REQUEST FOR TENDER RFT #B25-03

Washroom Upgrades
(Fenelon Twp PS, Bobcaygeon PS, IE Weldon SS, Lady Mackenzie PS)

TLDSB ADDENDUM NO. 8

- 2.1 This addendum applies to the **IE Weldon Secondary School** project only.
- 2.2 This addendum is issued to address the following:
 - 2.2.1 Clarification of scanning and coring requirements for the two new floor drains.
 - 2.2.2 Clarification of section detail at door head for both new doors.
 - 2.2.3 Clarification of flooring finishes.
 - 2.2.4 Clarification of scope of exposed plumbing re-work Rm 211.
 - 2.2.5 Clarification of door hardware.

RFT B24-02
STRUCTURAL UPGRADE &
REPAIRS - RM 210 & 211

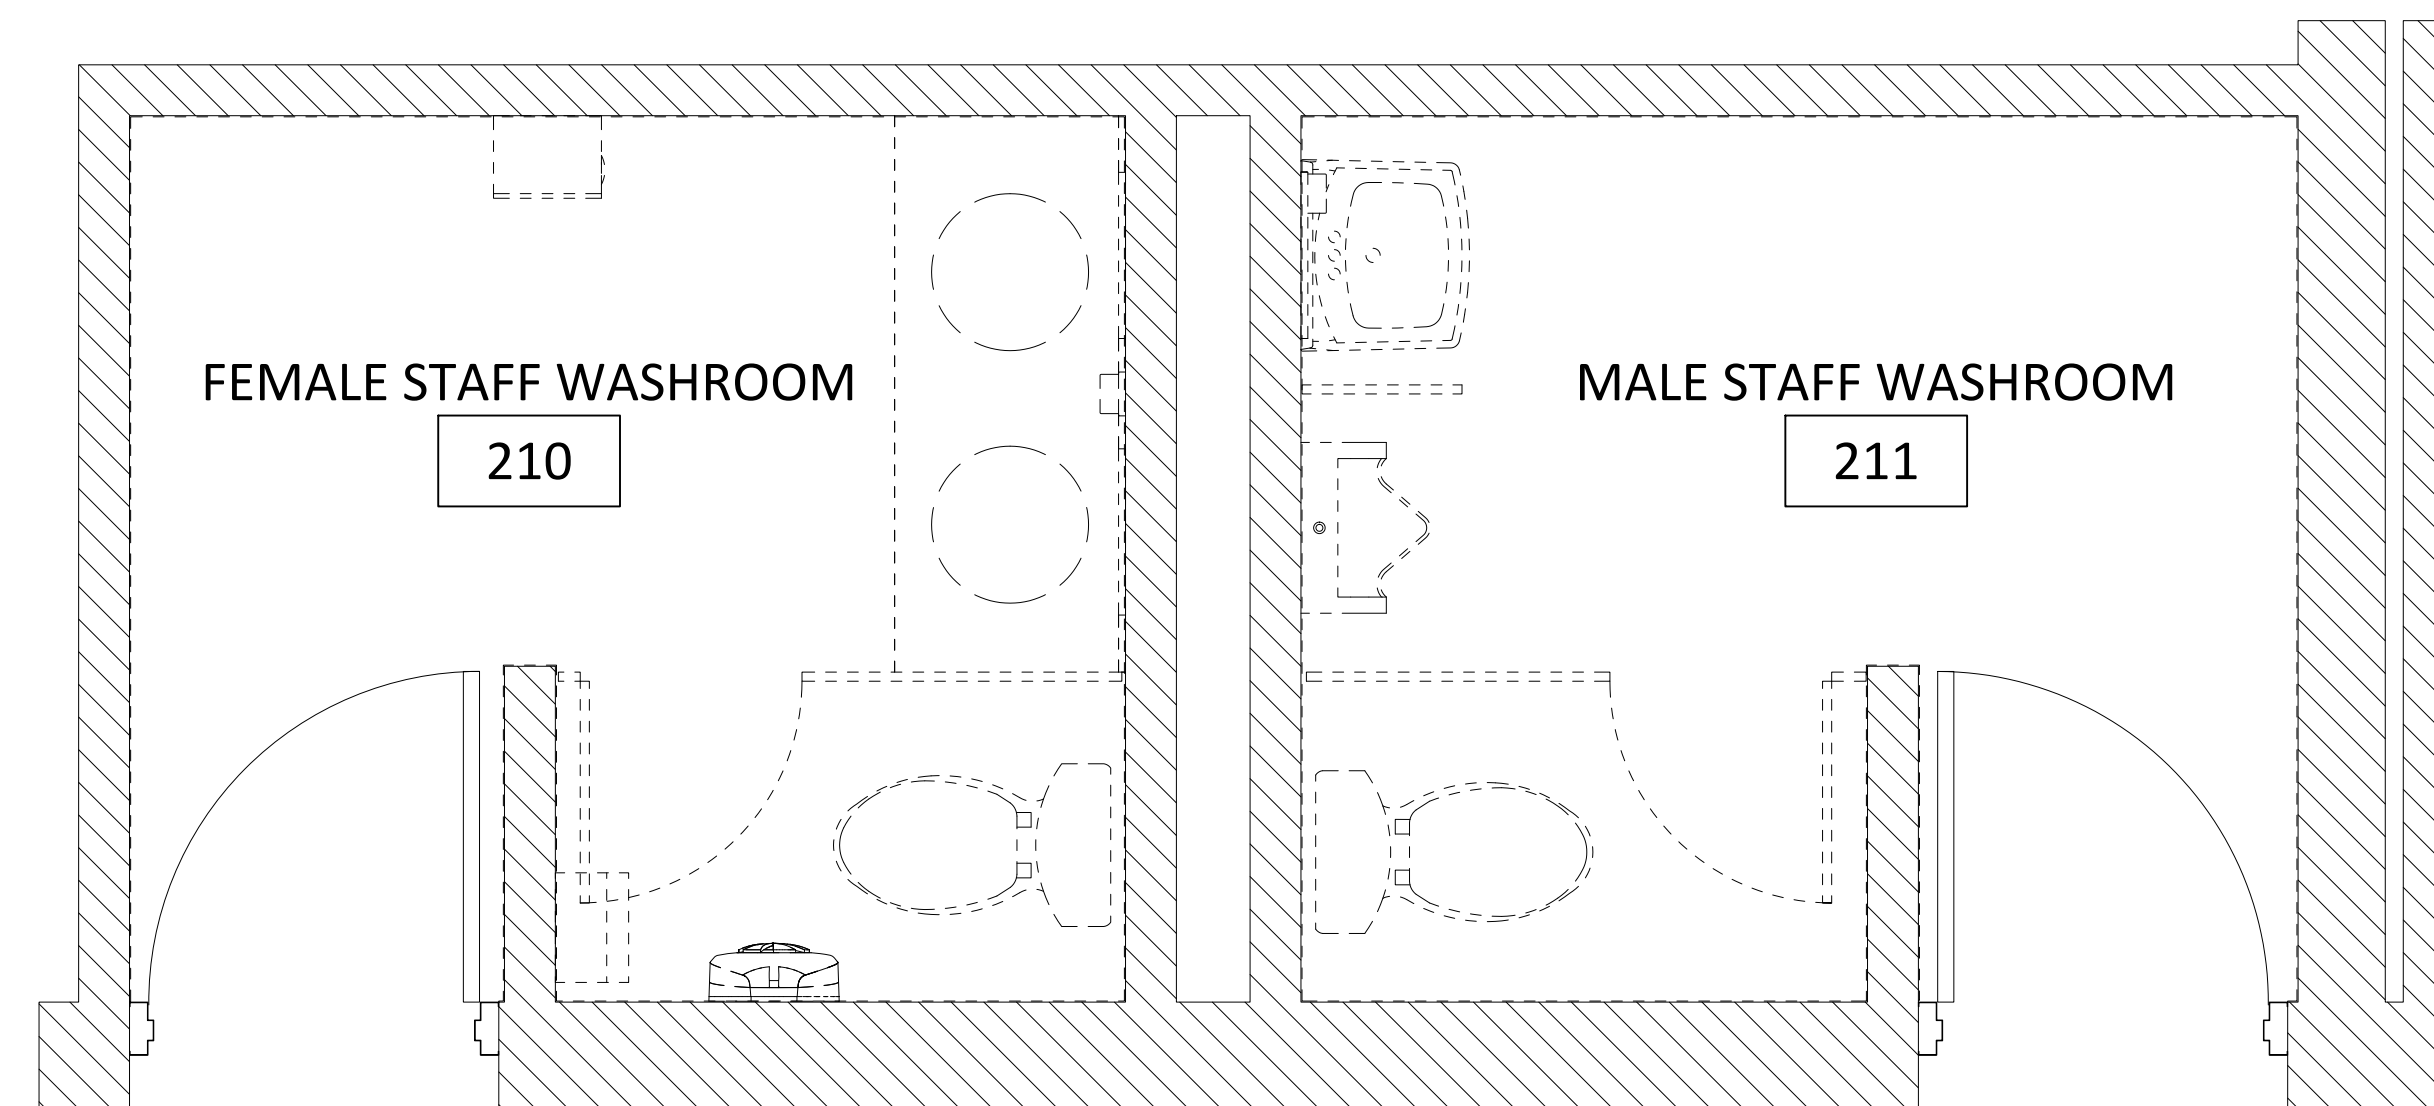
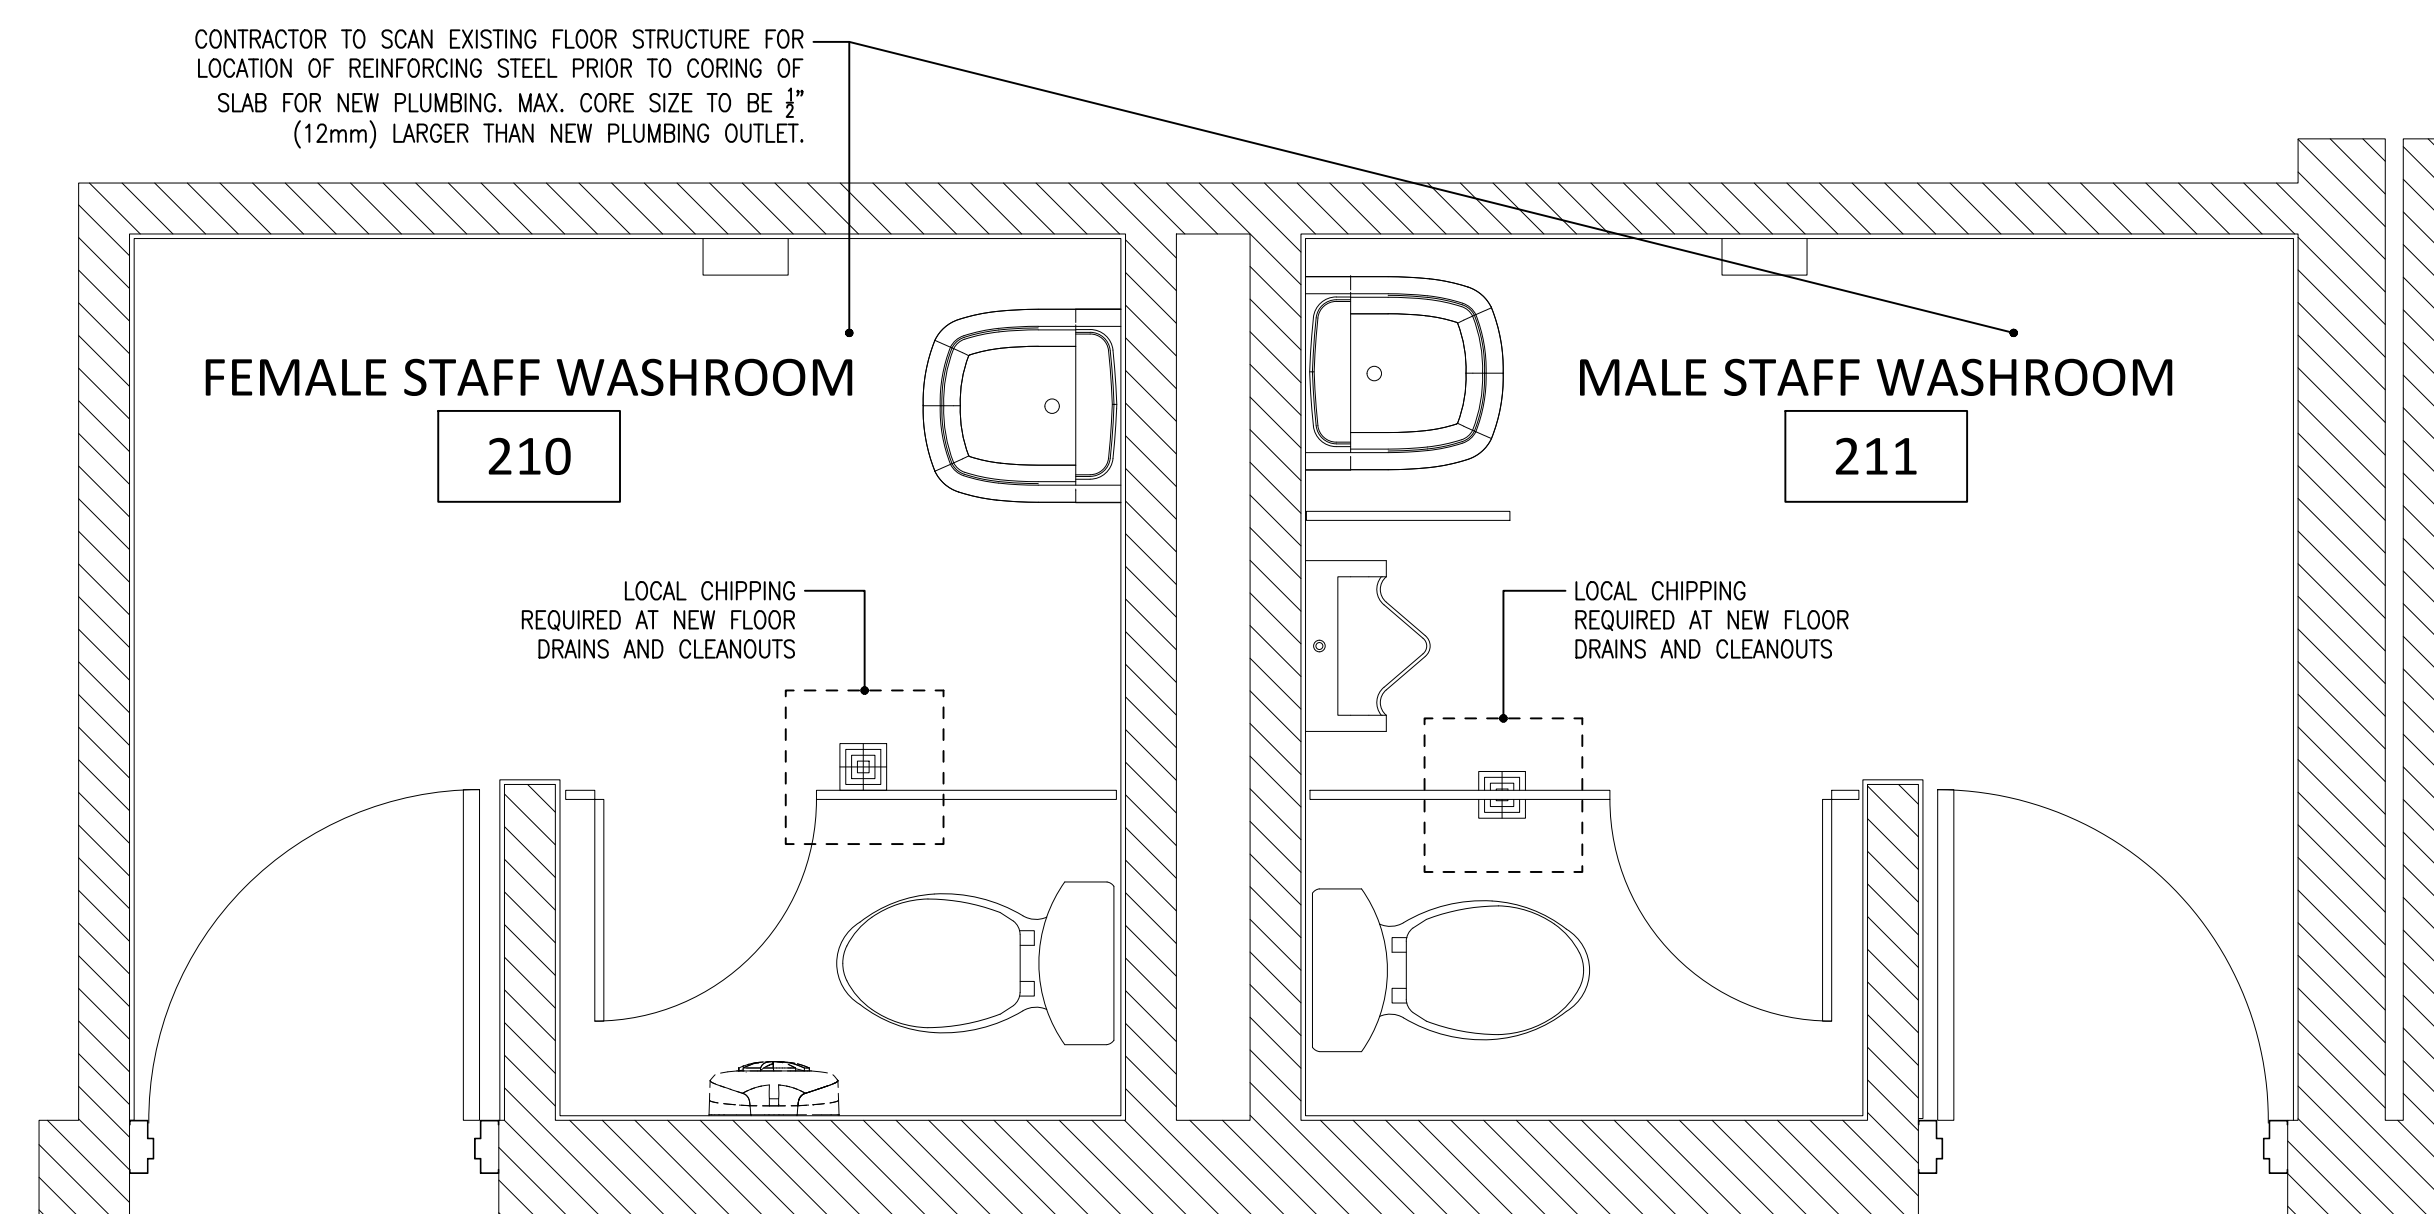
- 3.1 **Scanning and Coring requirements. Refer to attached structural drawing S1 for scanning and coring for the two new floor drains, one in each washroom.**
